N1092B-03

Modification Available Performance Enhancement Service Note

N1092B DCA-M Sampling Oscilloscope

An improved extinction ratio calibration is available for DCA-M Sampling Oscilloscopes with option 30A

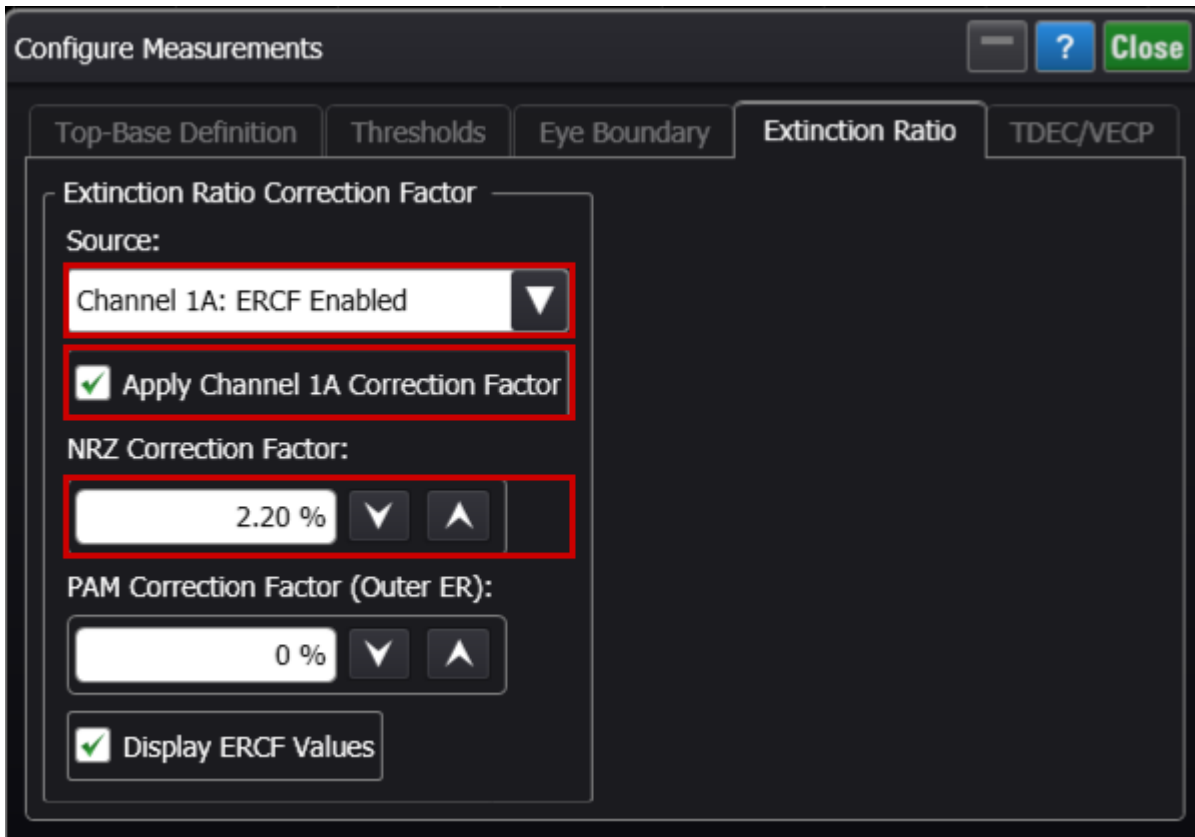
For N1092x DCA-M instruments with option 30A, units with the improved ER calibration are identified in the Help > About dialog with a “C1” annotation following the serial number.

- If the “C1” annotation is present, the unit has the improved ER calibration
- If the “C1” annotation is not present, the unit has the older ER calibration
